Department of Planning and Zoning

TO: Design Advisory Board
FROM: Scott Gustin 
DATE: September 23, 2014
RE: 15-0358CA, 82 University Place

Request: Demolish Angell Hall and Cook Physical Science Building, construct new STEM building with connecting bridge to Votey Hall.

LIGHTING PLAN

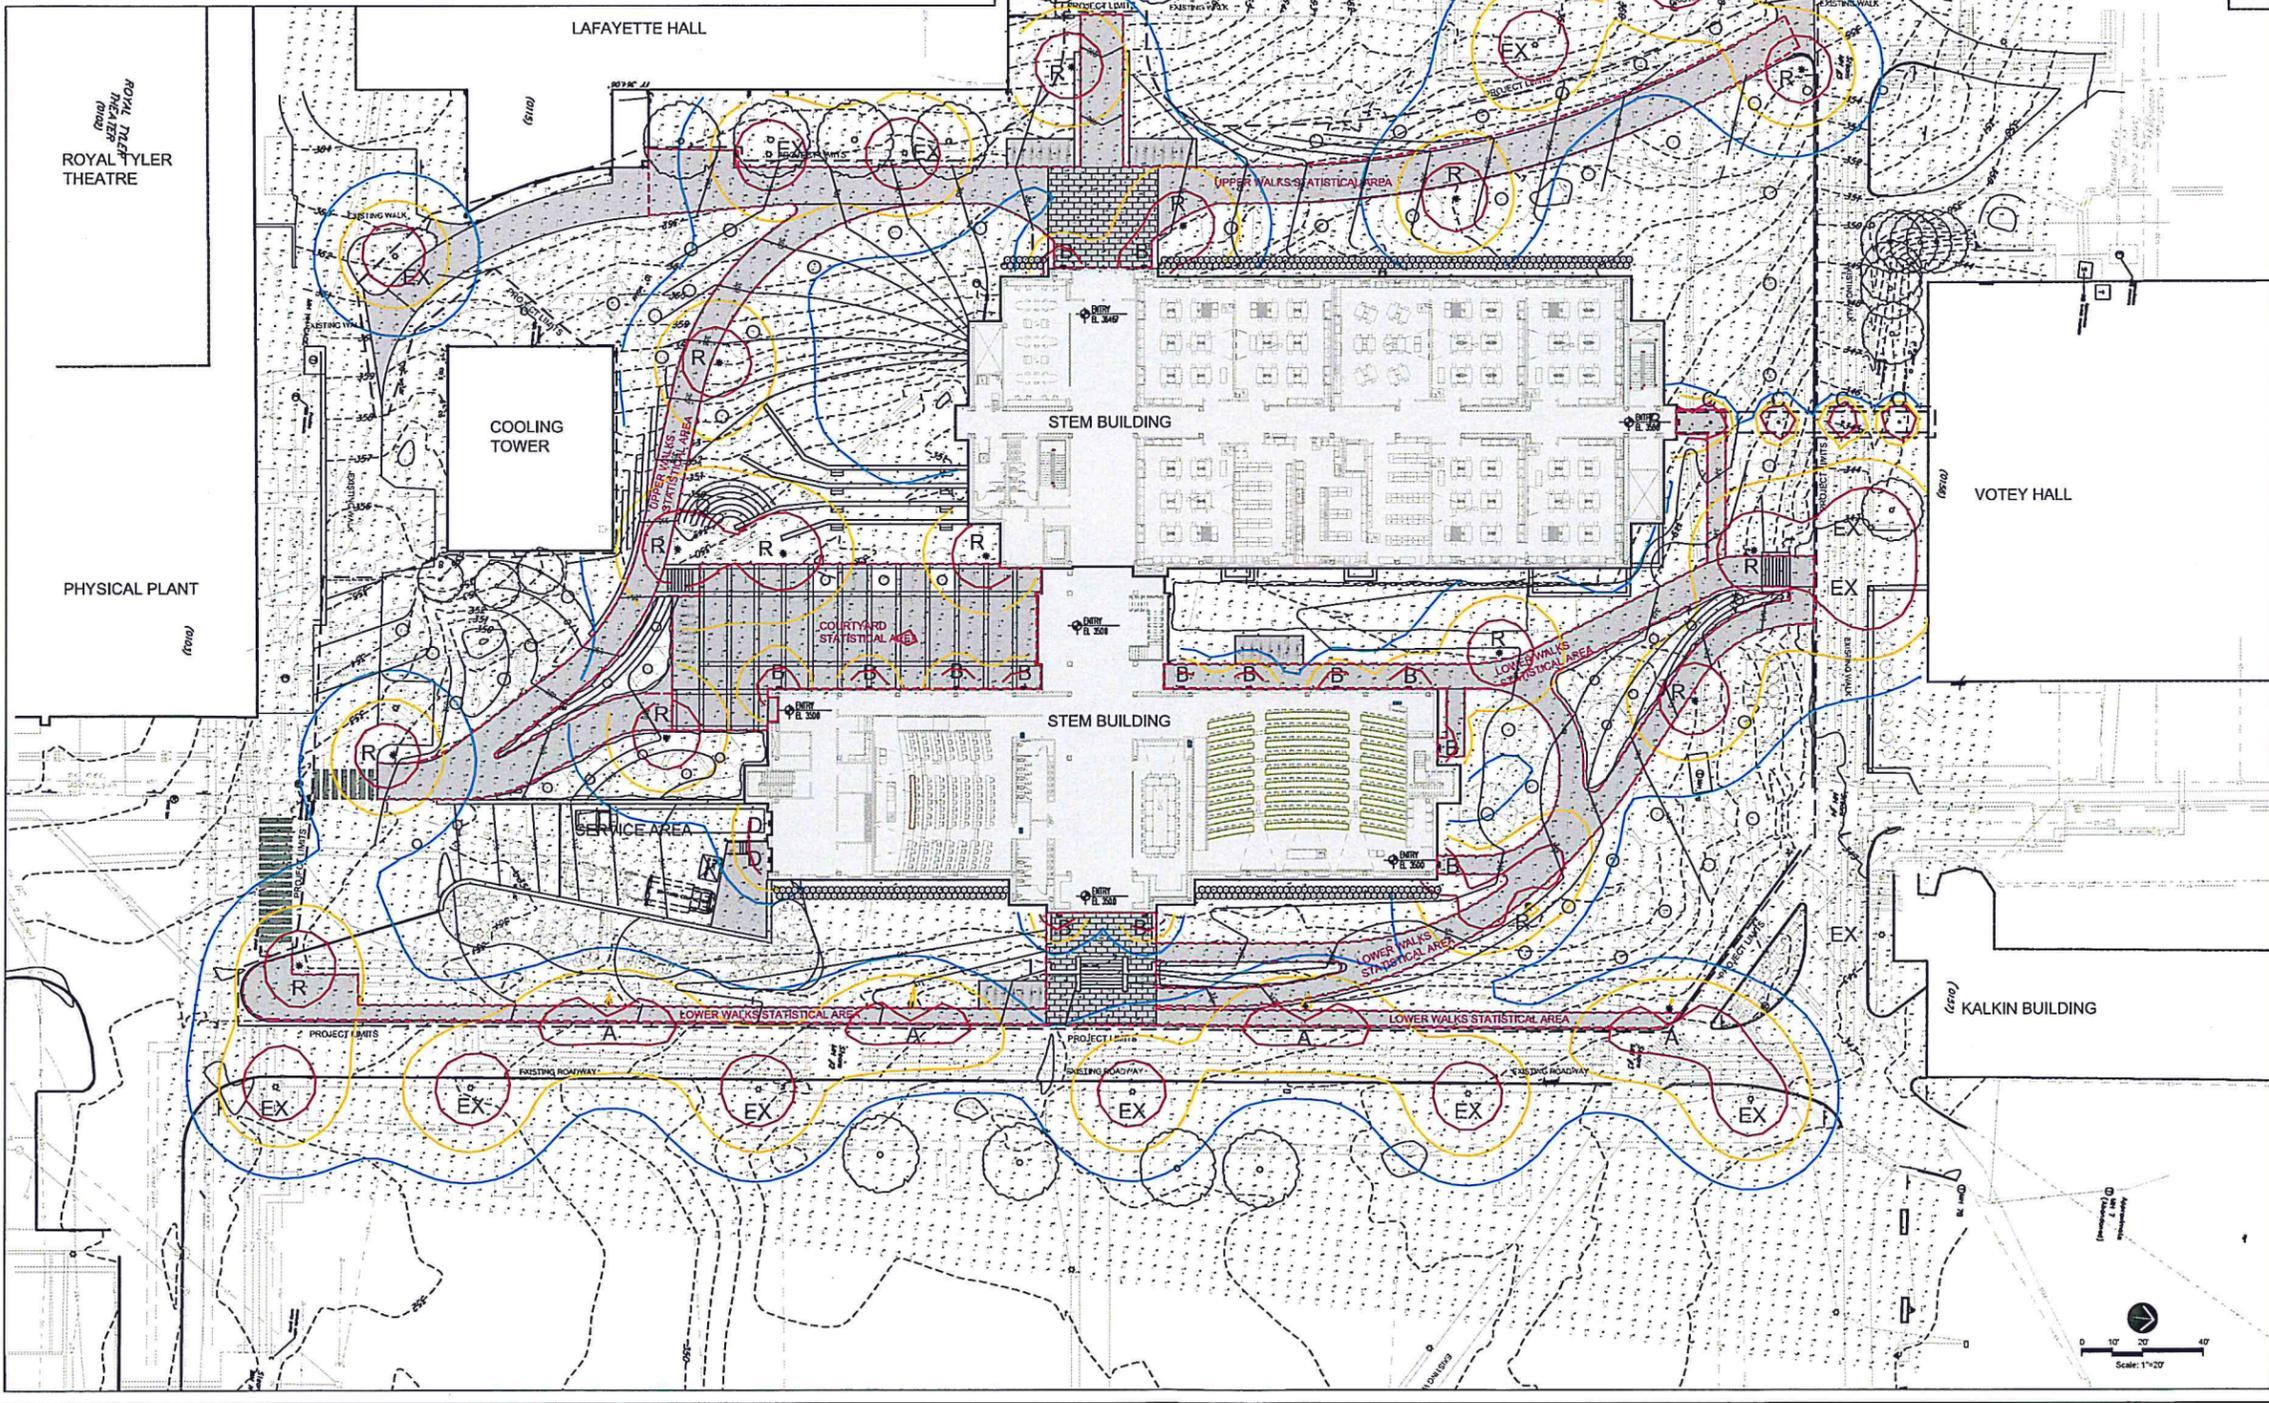
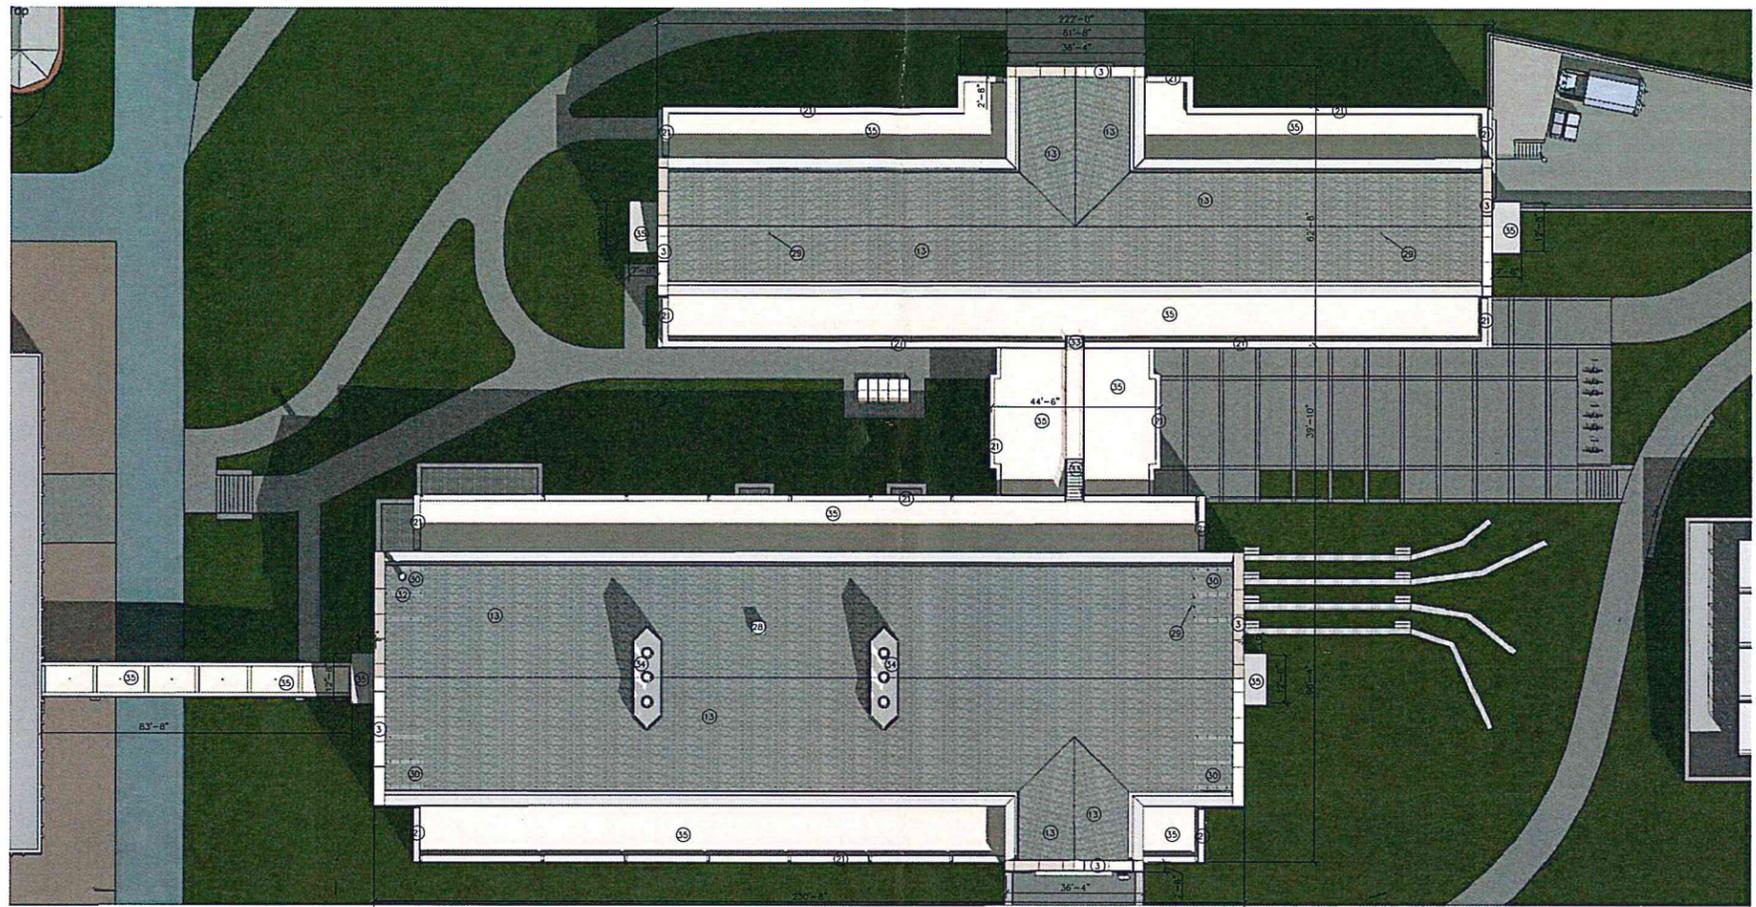
Building entries, walkways, and the plaza will be illuminated. A photometric plan has been submitted that depicts acceptable lighting levels throughout. While the photometric plan notes four fixture types (all LEDs), no fixture cut sheets have been provided and are needed.

1. Bicycle parking details (numbers, types, and locations) per Article 8: Parking, Part 2: Bicycle Parking.
2. Outdoor lighting fixture cut sheets.
3. Confirmation that the height of the western section of the proposed building does not exceed that of the Health Sciences Research Facility as measured above sea level.
